SERVICE BULLETIN

N° **189-314**

ATA 28 - AUXILIARY CENTRAL TANK UPGRADE

This Service Bulletin is issued in order to provide the necessary instruction to perform the upgrade from kit “auxiliary central tank” P/N 8G2810F00111 to “kit auxiliary central tank” P/N 8G2810F00112.

Figure 19

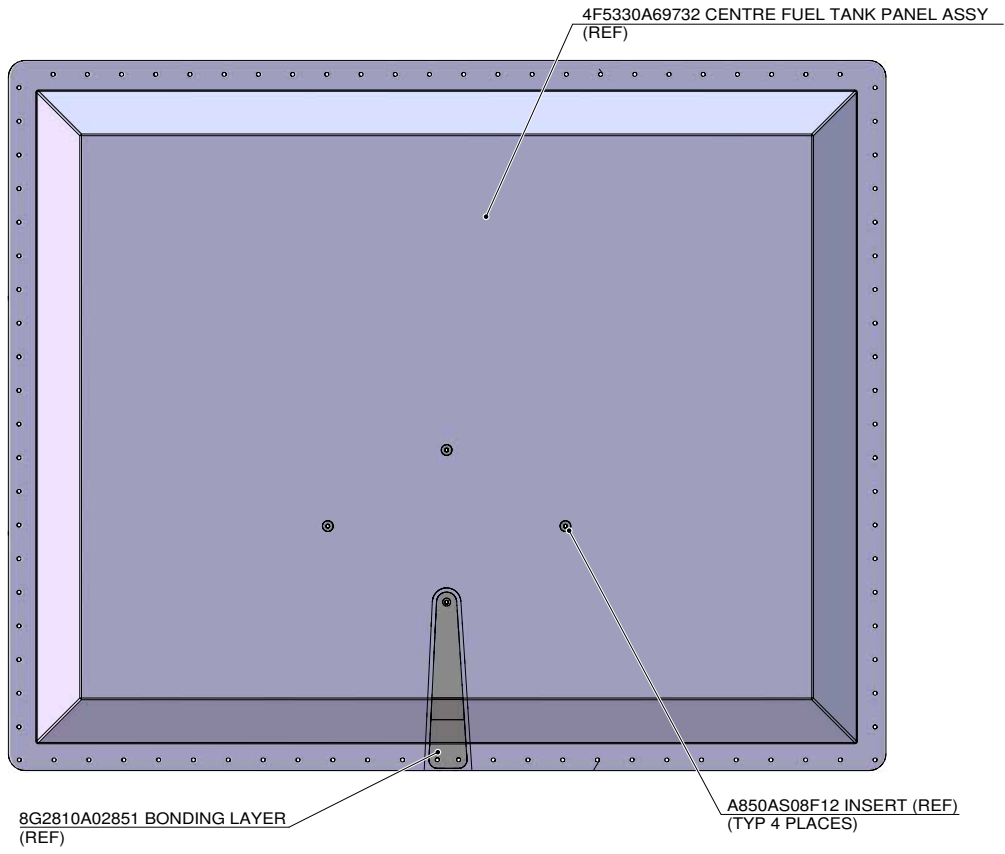
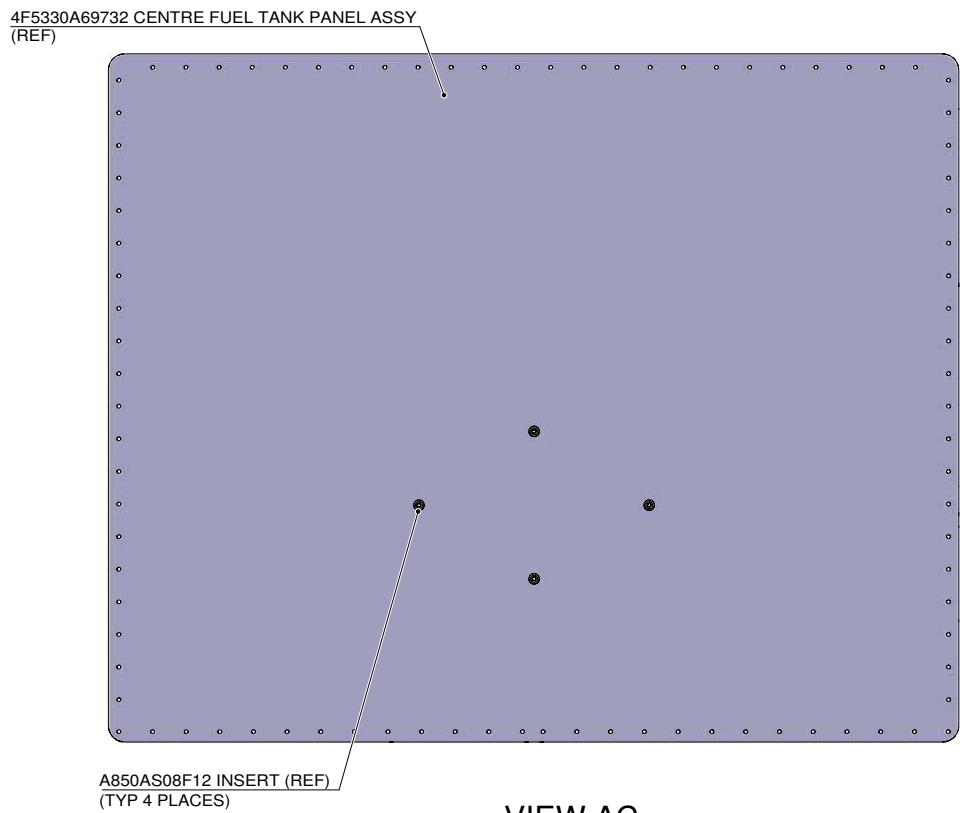
20. With reference to Figure 17 View Y, install the fuel auxiliary tank soft liner assy P/N 8G2580V00632 by means of n°46 screws P/N A428A3C08.
21. With reference to Figure 19 View AB and View AC, re-mark the previously removed centre fuel tank panel assy P/N 4F5330A69732 with P/N 8G5330A97631 (Ref. step 3.2).

Figure 21

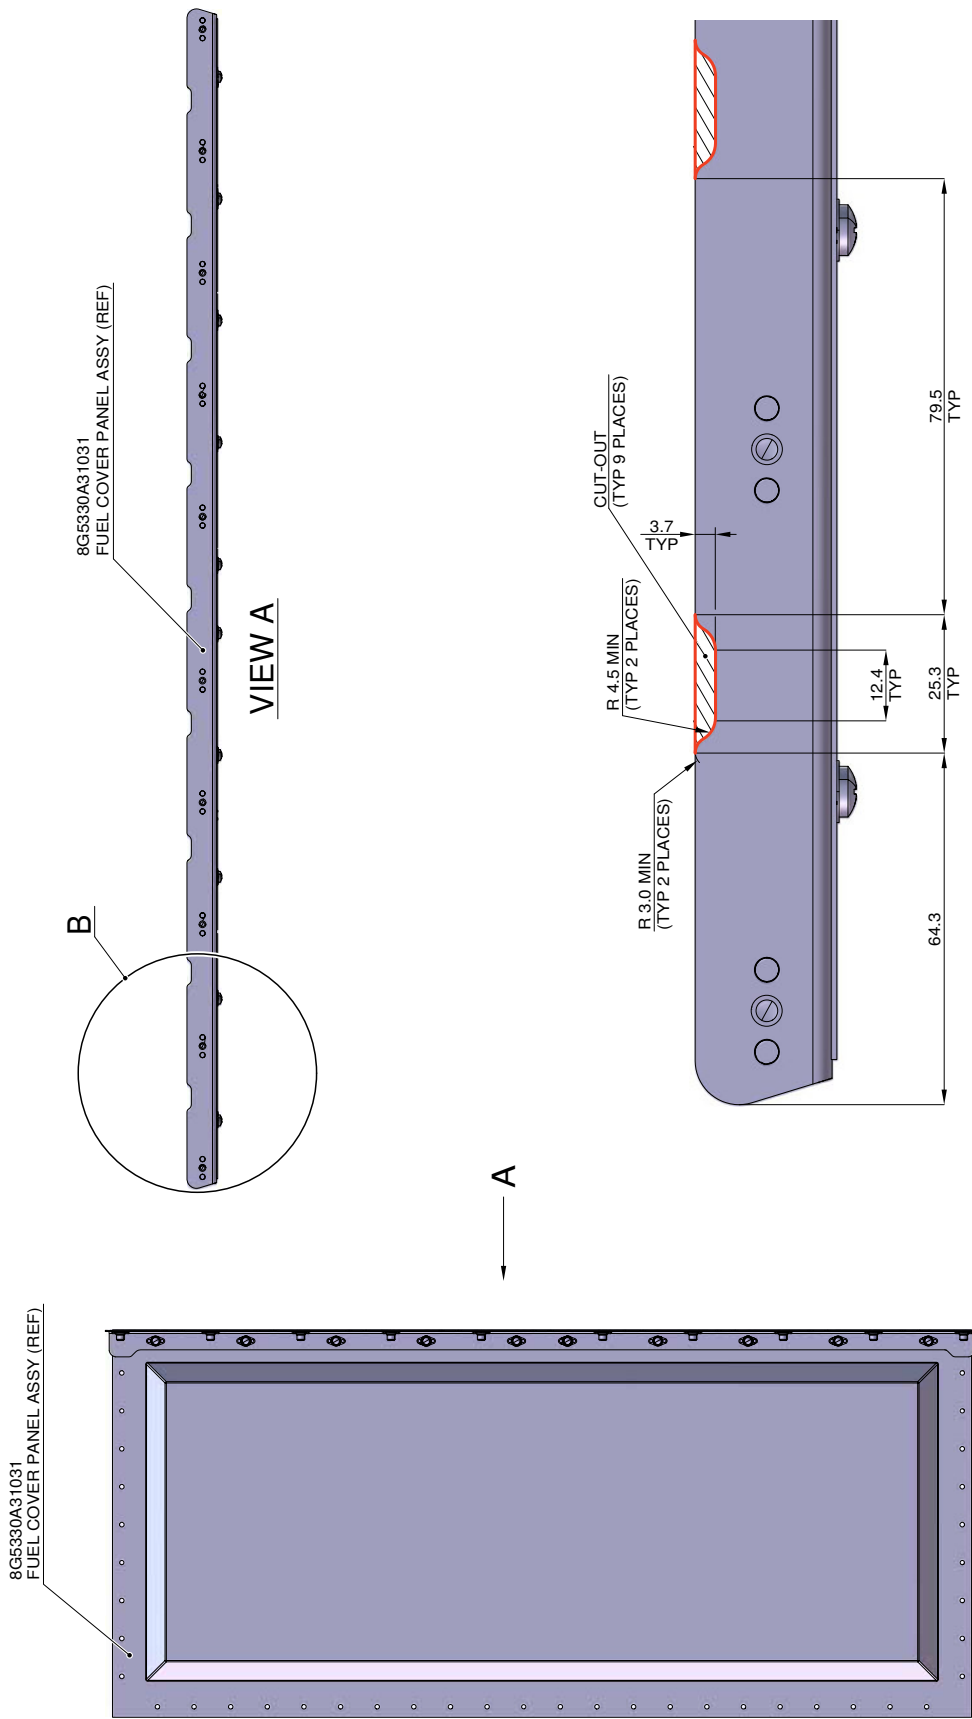
24. With reference to Figure 20 View AD, install n°4 screws P/N MS24693-A58.
25. With reference to Figure 21, rework the panel P/N 8G5330A31031 as indicated.

26. With reference to Figure 21, re-mark the panel P/N 8G5330A31031 with P/N 8G5330A97731.
27. In accordance with AMP DM 89-A-28-11-00-00A-364A-A, perform the leak check of the fuel tank installation.

Figure 23

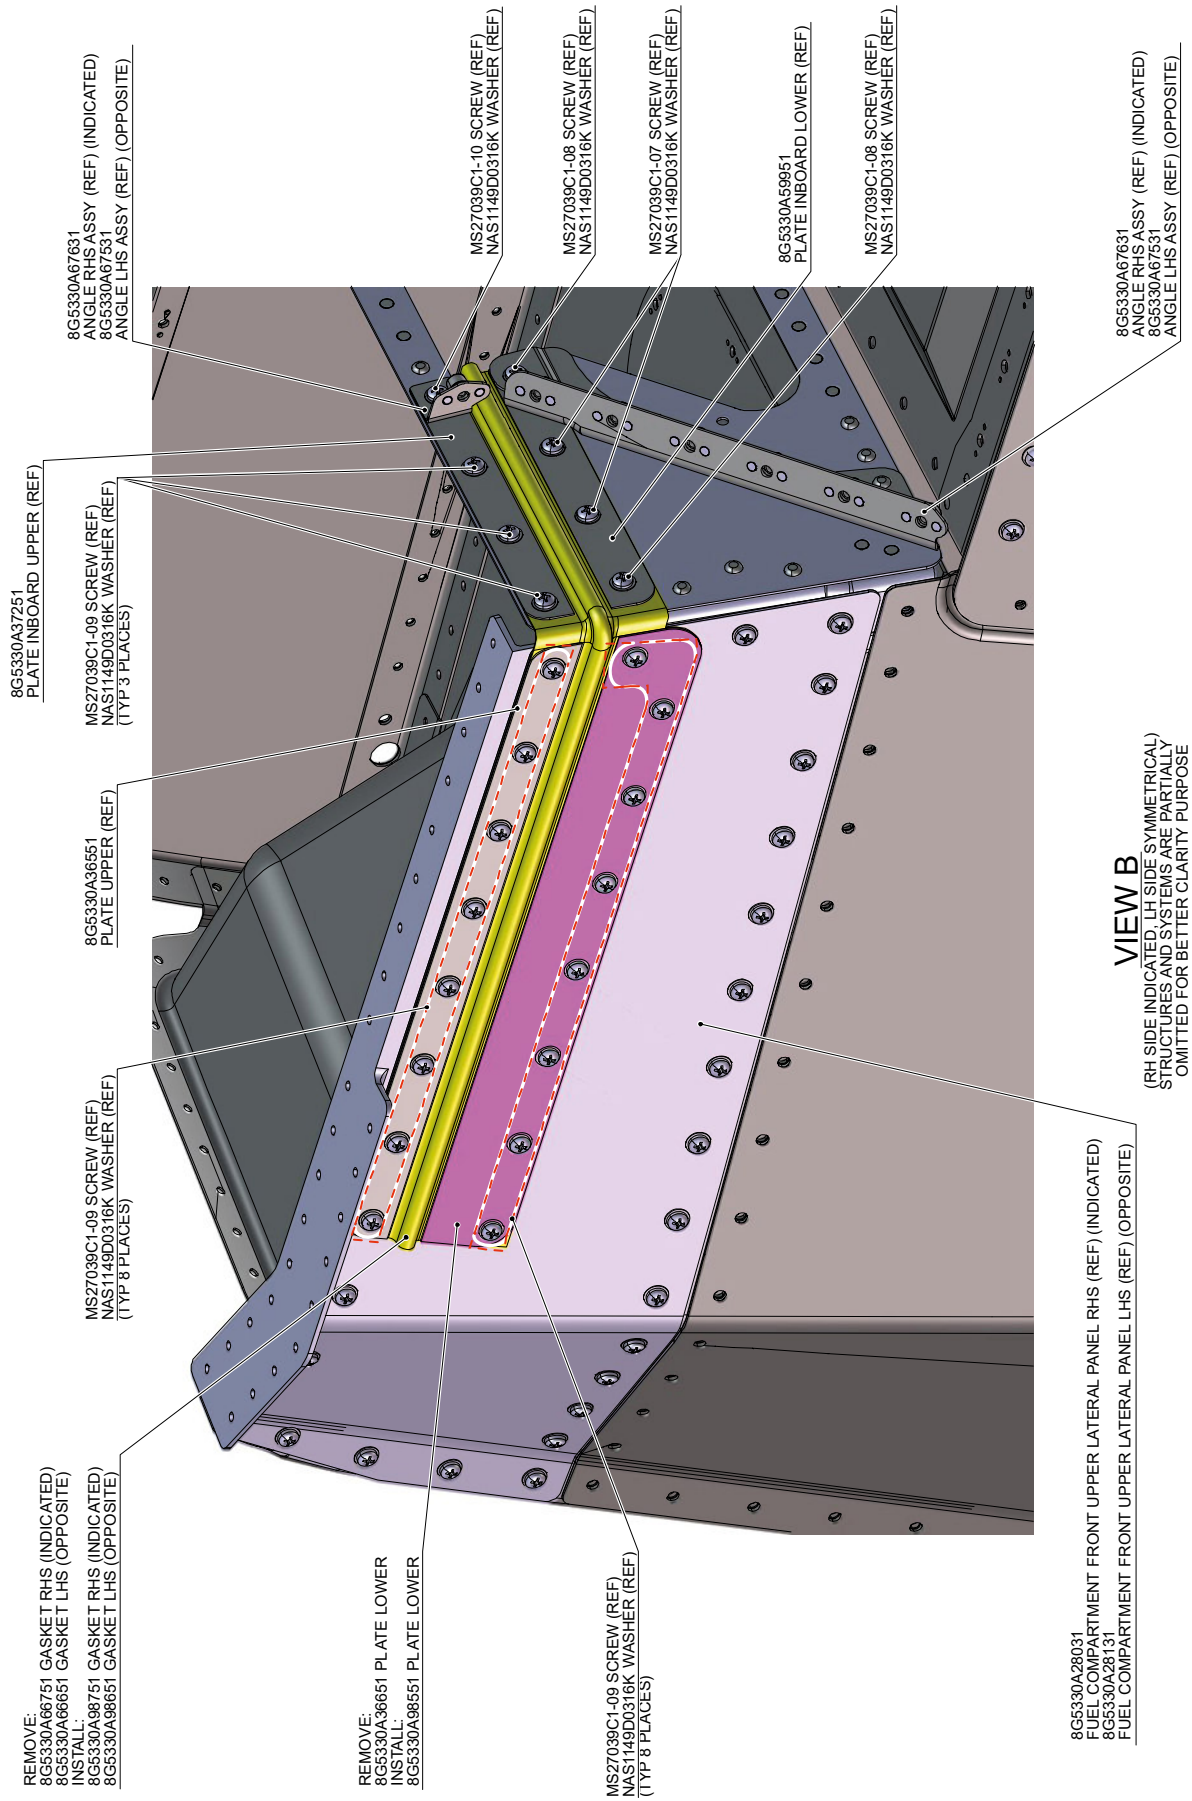
- 3.5 With reference to Figure 23 View B, remove the plate lower P/N 8G5330A36651 with the related hardware and the gasket RHS P/N 8G5330A66751. Discard the plate and the gasket, retain fixed hardware for later re-use.

- 3.6 With reference to Figure 23 View B, install the new plate lower P/N 8G5330A98551, the new gasket RHS P/N 8G5330A98651 and re-install the plate upper P/N 8G5330A36551, the plate inboard upper P/N 8G5330A37251, the plate inboard lower P/N 8G5330A59951 and the angle RHS assy P/N 8G5330A67631 by means of the previously removed hardware (Ref. Steps 3.4 and 3.5) on the fuel compartment front upper lateral panel RHS P/N 8G5330A28031.

- 3.8 With reference to Figure 23 View B, remove the plate lower P/N 8G5330A36651 with the related hardware and the gasket LHS P/N 8G5330A66651. Discard the plate and the gasket, retain fixed hardware for later re-use.

- 3.9 With reference to Figure 23 View B, install the new plate lower P/N 8G5330A98551, the new gasket LHS P/N 8G5330A98751 and re-install the plate upper P/N 8G5330A36551, the plate inboard upper P/N 8G5330A37251, the plate inboard lower P/N 8G5330A59951 and the angle LHS assy P/N 8G5330A67531 by means of the previously removed hardware (Ref. Steps 3.7 and 3.8) on the fuel compartment front upper lateral panel LHS P/N 8G5330A28131.
